AEBS-HDV-06 industry prep

AEBS-HDV-06

September 21-22, 2021

Support for discussion

1 5.2.1.4 - What is the issue?

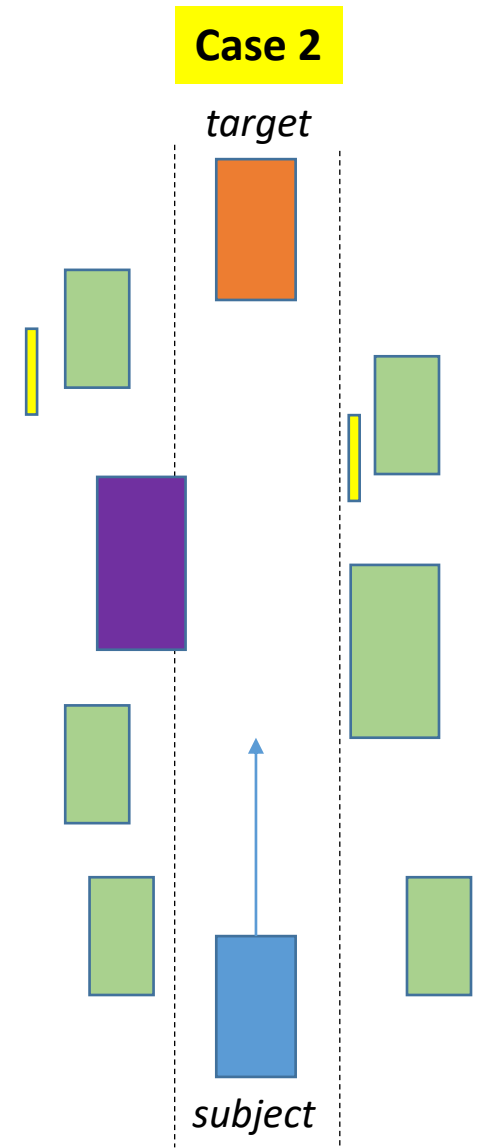
1. Assuming that in these 3 cases here conditions (a) to (g) are all fulfilled, the system is expected to deliver the required performance.

2. However, it can be easily understood that in cases 2 and 3, the performance will be affected by conditions which are not named in the (a) to (g) list, i.e.

- Complexity of the situation
- Brake temperature

3. The issue is that current wording of 5.2.1.4 does not clearly acknowledge this.

Proposal to amend 5.2.1.4.

- (h) **In unambiguous situations (e.g. not multiple potential targets ~~no motorcycle nor bicycle in between rows of vehicles, no laterally waving vehicle in the adjacent lanes~~)**

2 Vehicle longitudinal centre planes (offset) Proposal

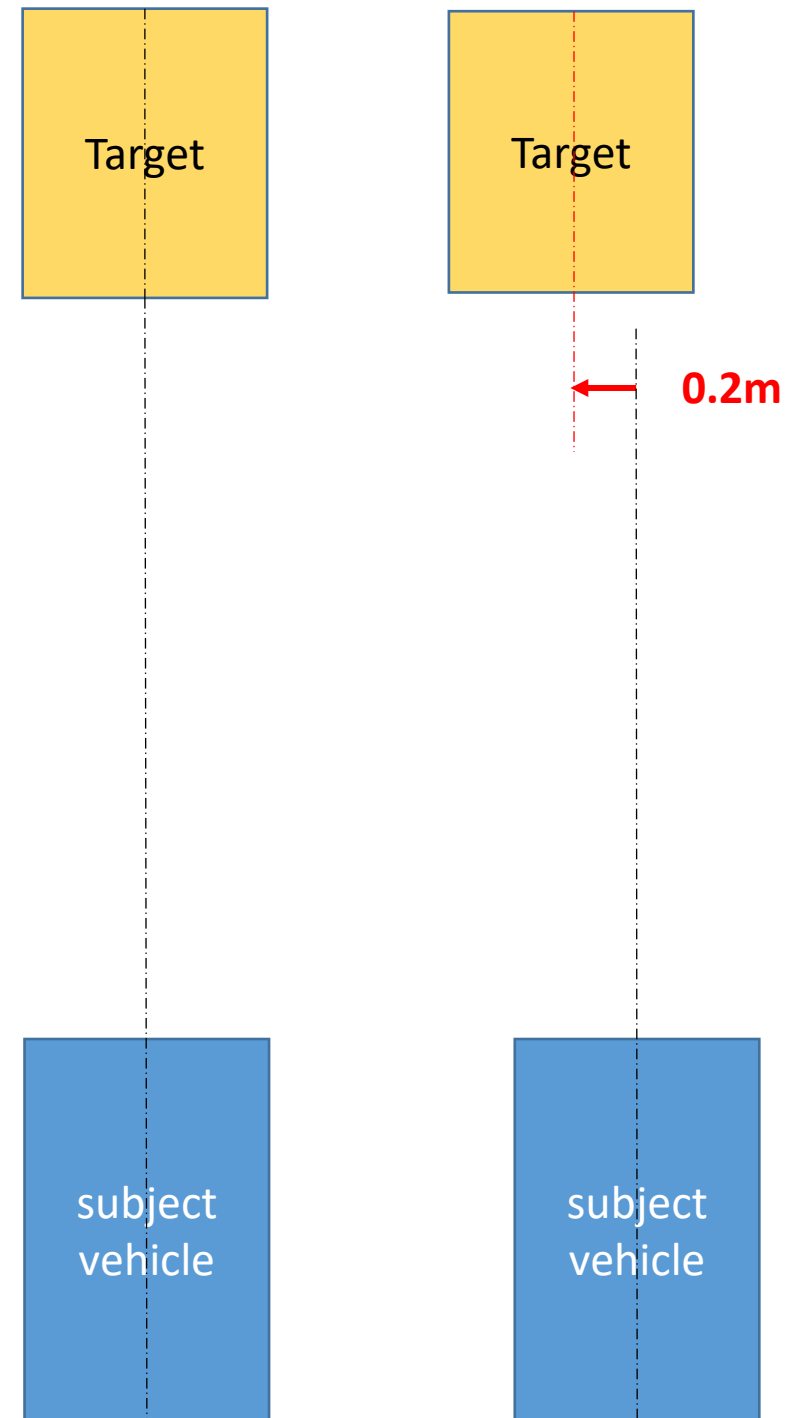
We still believe the current wording is ambiguous. Indeed, if center planes (with plural form) are displaced by 0.2m, it means that both the center plane of the target and of the subject vehicle are displaced by 0.2m (otherwise, why using plural form?).

Proposal to amend:

- (d) In situations where ~~the vehicle longitudinal centre planes are~~ **the anticipated impact point is** displaced by **not more than 0.2 m compared to the vehicle longitudinal centre plane**;

The proposal is to copy the same wording as in 5.2.2.4 and 5.2.3.4 to avoid any possible misunderstanding (and avoid creating a new wording).

*This would then make fully clear the following **interpretation**: “the performance shall be delivered in case the centre plane of the target vehicle is moved by up to 0.2m to the left or to the right”.*

2 Vehicle longitudinal centre planes (offset) Interpretation

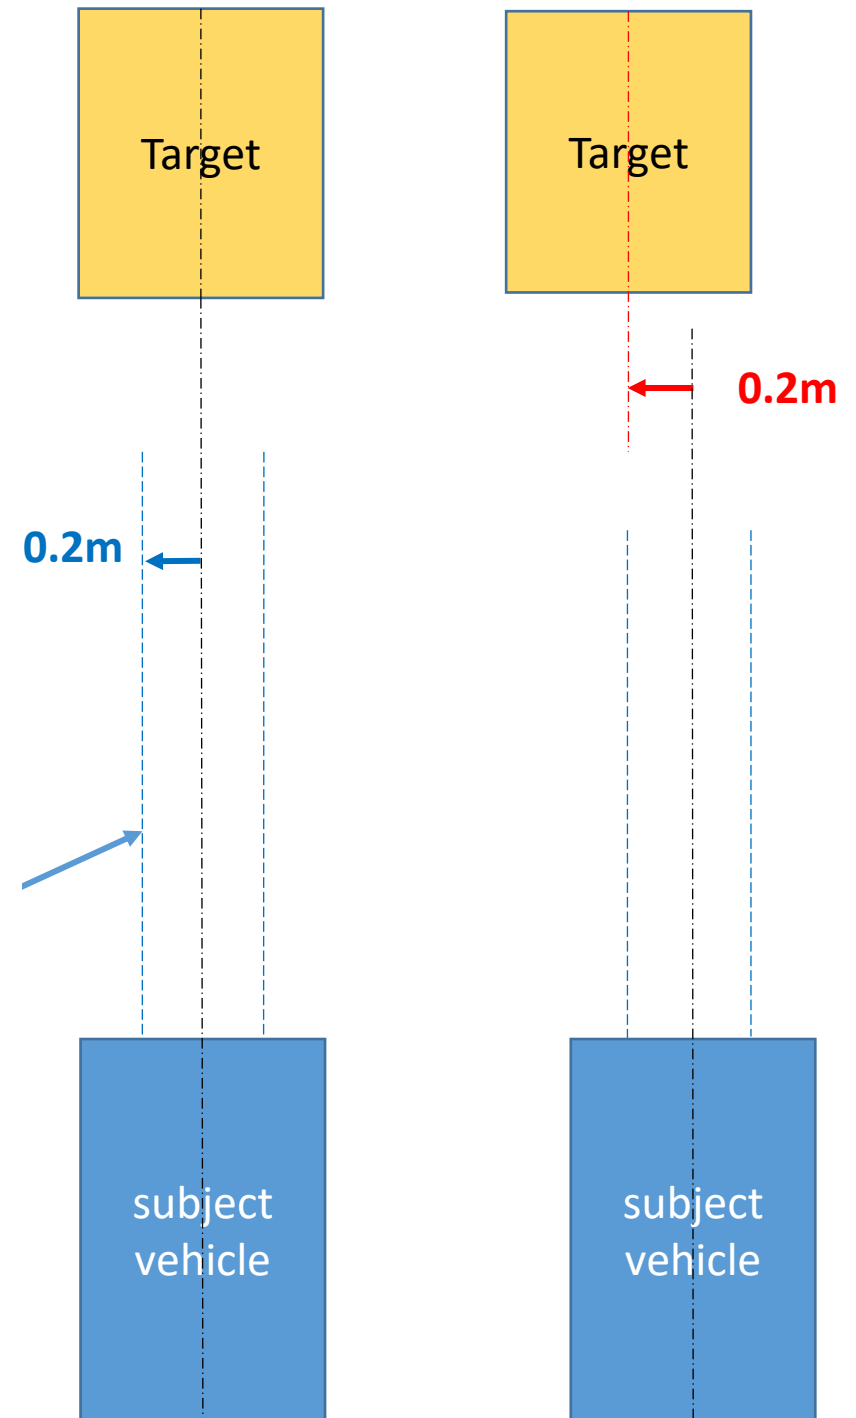
- (d) In situations where ~~the vehicle longitudinal centre planes are the anticipated impact point~~ is displaced by **not more than 0.2 m** compared to the vehicle longitudinal centre plane;

- 6.5 The subject vehicle and the moving target shall travel in a straight line, in the same direction, for at least two seconds prior to the functional part of the test. with a subject vehicle to target centreline offset of **not more than 0.2m**.

2 Vehicle longitudinal centre planes (offset) Interpretation

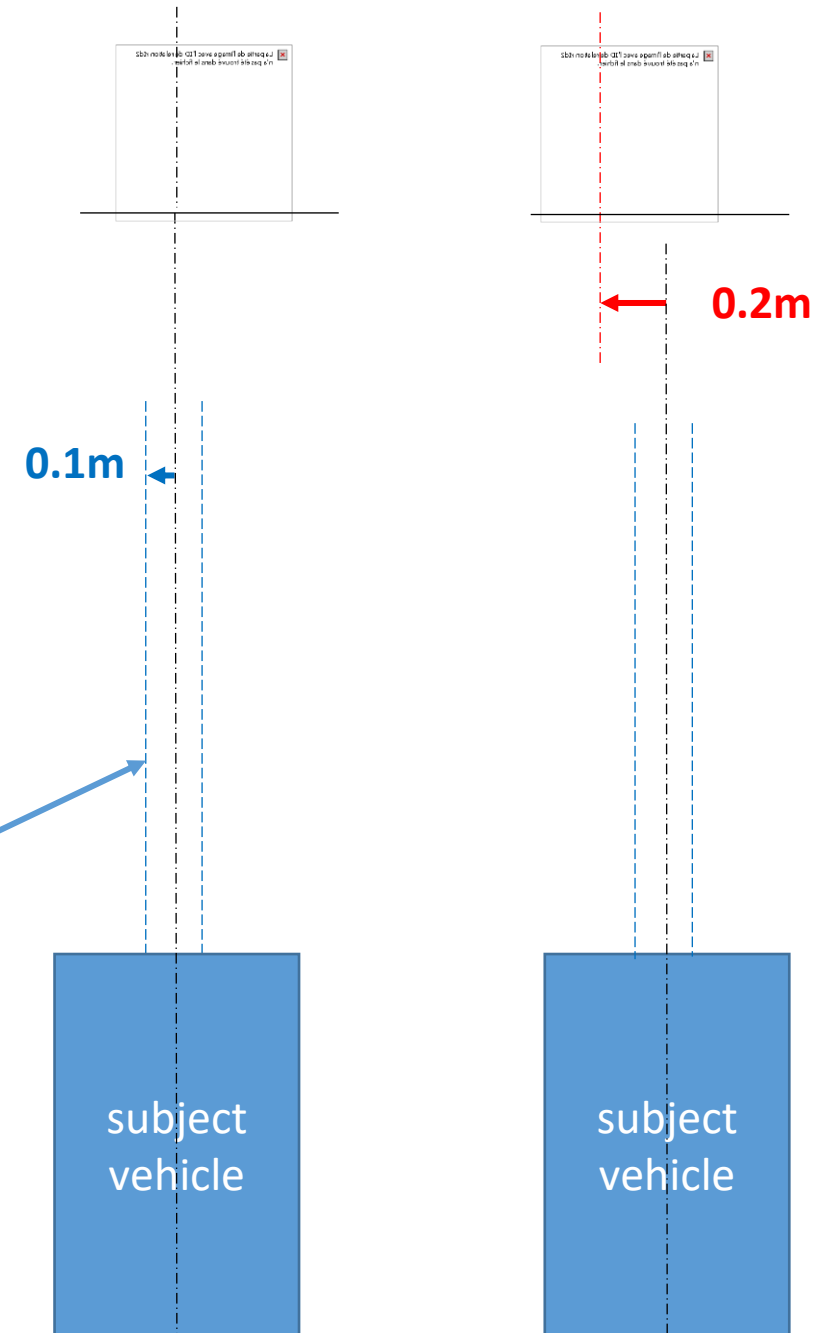
- (e) In situations where the anticipated impact point is displaced by **not more than 0.2 m** compared to the vehicle longitudinal centre plane;

- 6.6.1. The subject vehicle shall approach the impact point with the pedestrian target in a straight line for at least two seconds prior to the functional part of the test with an anticipated subject vehicle to impact point centreline offset of **not more than 0.1 m**.

*During the test,
the vehicle shall
stay within a +/-
0.2m corridor*

V2P braking time logic applied to a HDV

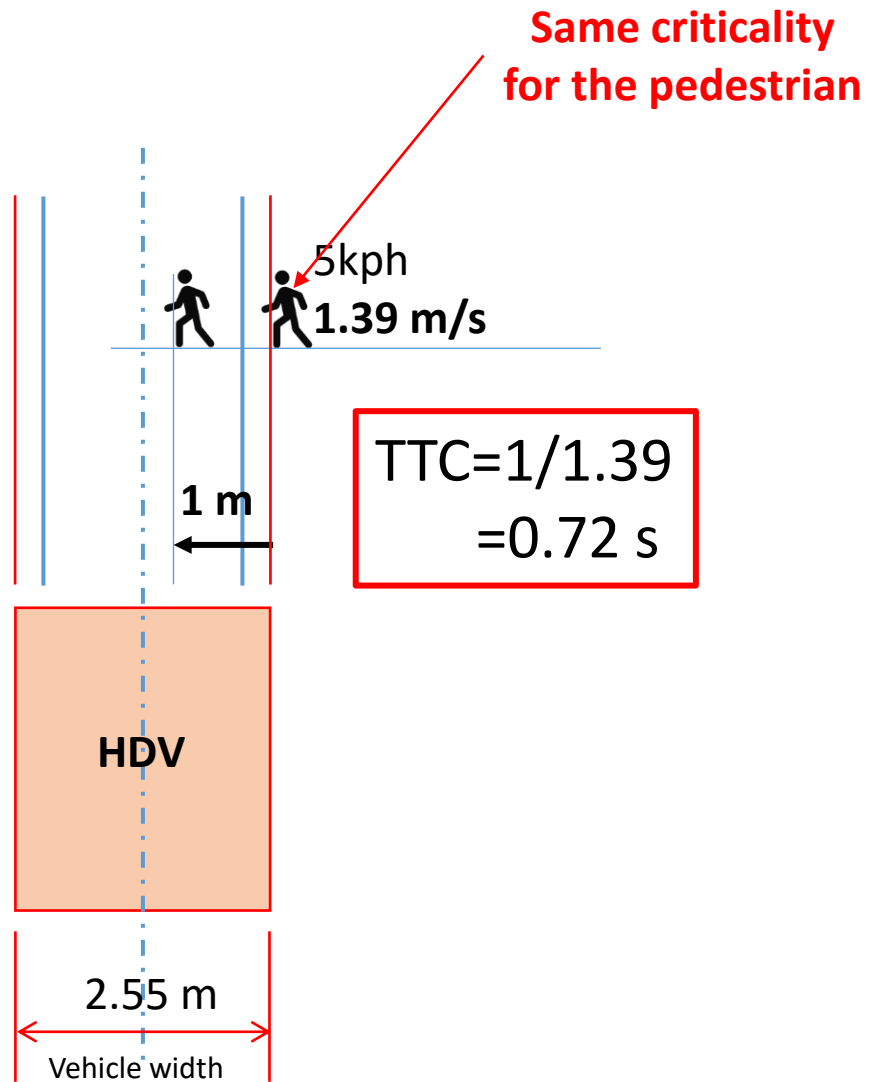
- Adopt the principle of an “ISO-criticality” for the pedestrian to HDVs
(No intention to change R152 principles)

- Decel	6m/s ²	7m/s ²
- T1g	1s	1s
- TTC	0.72s	0.72s
- Peak avoidance speed	19 kph	20 kph

Both approaches are consistent with a peak avoidance speed **around 20kph**, which also reflects the state-of-the-art (of one OEM)
